***State Significant Development (SSD 23512960)
Glenwood High School Upgrade***

Independent Environmental Audit 2

Glenwood High School Upgrade

Photo 28: Concrete pad made with excess concrete to stabilise the truck turning area in the north east of the site (A2_NC05)

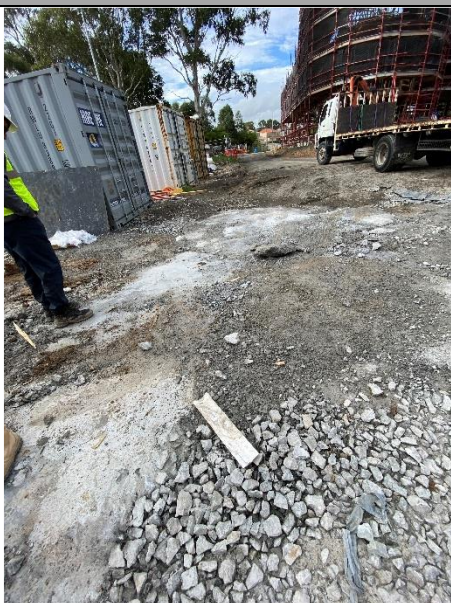
A2_NC05	C31	The Applicant must ensure that concrete waste and rinse water are not disposed of on the site and are prevented from entering any natural or artificial watercourse.	Ensure the concrete pad in the driveway turning area and adjacent soil are removed and disposed of appropriately prior to landscaping of the area. Maintain evidence (waste docket, include clearance certificate, photos) and provide for Audit 3.	Open
A2_NC06	38	In accordance with the specific requirements in the Independent Audit Post Approval Requirements (2020), the Applicant must: (a) review and respond to each Independent Audit Report prepared under condition C35 of this consent, or condition C36 where notice is given by the Planning Secretary;	Ensure the Applicants response to Audit 1 improvement opportunities, is provided to the Planning Secretary.	Open
